Response to
Request for Additional Information No. 2, Supplement 1, Revision 0

U. S. EPR Standard Design Certification

AREVA NP Inc.

Docket No. 52-020

Figure 19-07-1—Operational Chilled Water System Representative Simplified Drawing

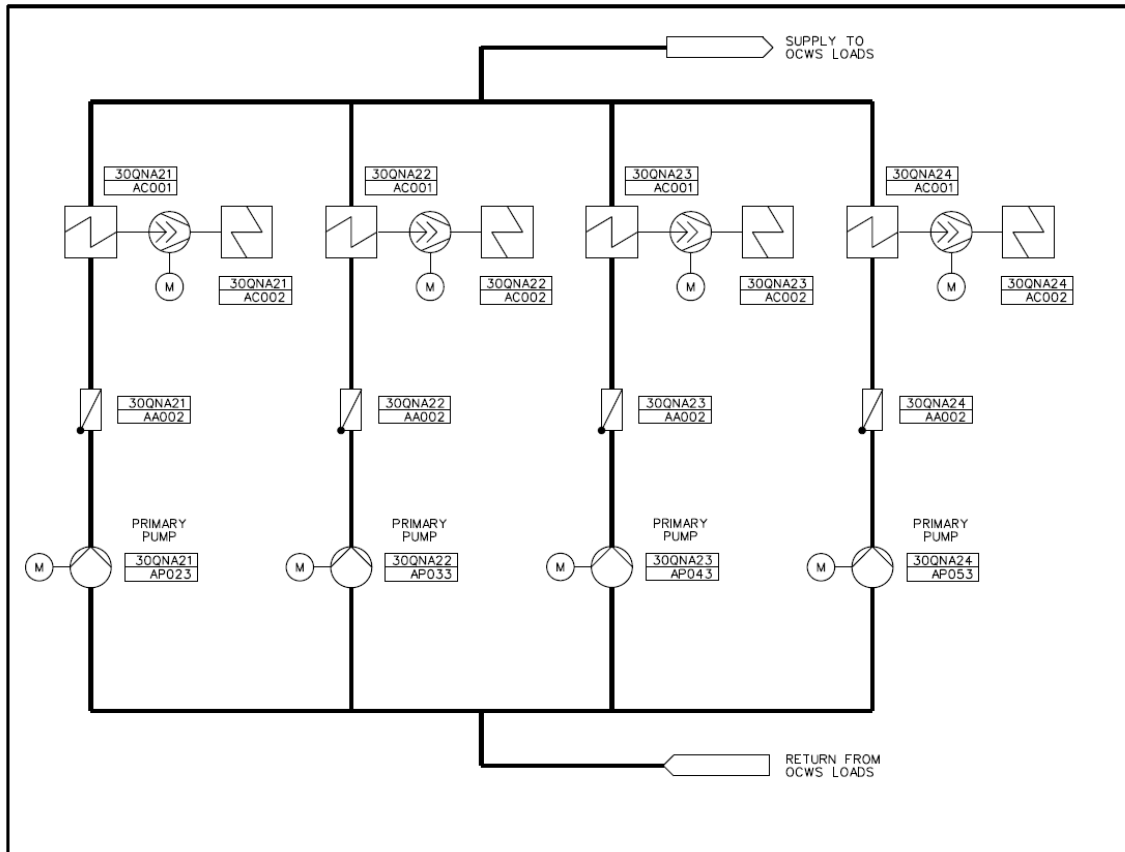
Please provide system information (including a description and system drawing or fault tree) as assumed in the PRA for the closed cooling water system, auxiliary cooling water system, and operational chilled water system. These systems appear to be modeled in the PRA, but no information on the systems could be found in the rest of the FSAR.

The operational chilled water system (OCWS) is a non-safety system that has the capability to provide chilled water to various plant systems during normal plant operation. The OCWS consists of four trains. Each train's capability is 33% under the most limiting conditions (highest outside temperature).

The major components for each train are:

- Pump (QNA 21/22/23/24 AP 23/33/43/53).
- Chiller Unit (QNA 21/22/23/24 AN 001).

Each of the four chiller units is cooled by the component cooling water system (CCWS) common header (CH). Two units are cooled by CCW CH1, two units are cooled by CCW CH2.

The OCWS is credited in the PRA to provide chilled water to the electrical division of the Safeguard Building ventilation system (SAC). The OCWS is used as a backup when the safety chilled water system (SCWS /QKA) is unavailable for maintenance or fails during operation.

The PRA model assumes that two OCWS trains are sufficient to provide adequate cooling to the electrical rooms during the mission time of 24 hours. The preferred alignment of the OCWS is to supply cooling to electrical Division 2 and 3 rather than Division 1 and 4.

A simplified drawing of the OCWS as modeled in the PRA is provided in Figure 19-07-1.
